## DCCBNA Recall Bulletin

### Exhaust Elbow Failures

**Subject: SAFETY DEFECT – Exhaust Elbow 070774434**

**Models:** Orion VII

**Figure 1-2 Exhaust Elbow Welds**

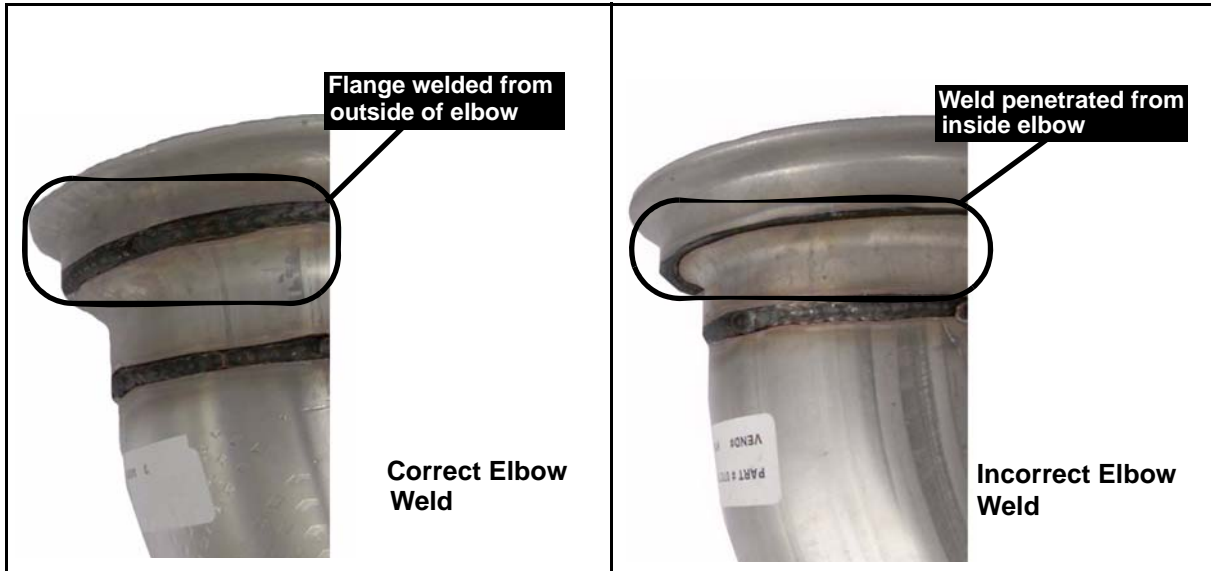
**Defect:** A weld on an exhaust elbow, part number 070774434, was incorrectly manufactured.

5. Inspect exhaust elbow for correct welds. [See Figure 1-2](#)
  - a. If welds are found to be incorrect, exhaust elbow must be replaced. [See "Procedure" on page 4.](#)
  - b. If welds are found to be correct, no procedure needed, secure exhaust blanket clips, close engine compartment access door and turn battery isolator switch to the ON position.

1. Install new exhaust elbow **070774434** at the exhaust flex pipe.
2. Secure the two exhaust elbow v-clamps.
3. Close the engine compartment access door.
4. Secure exhaust blanket clips.
5. Turn battery isolator switch to the ON position.
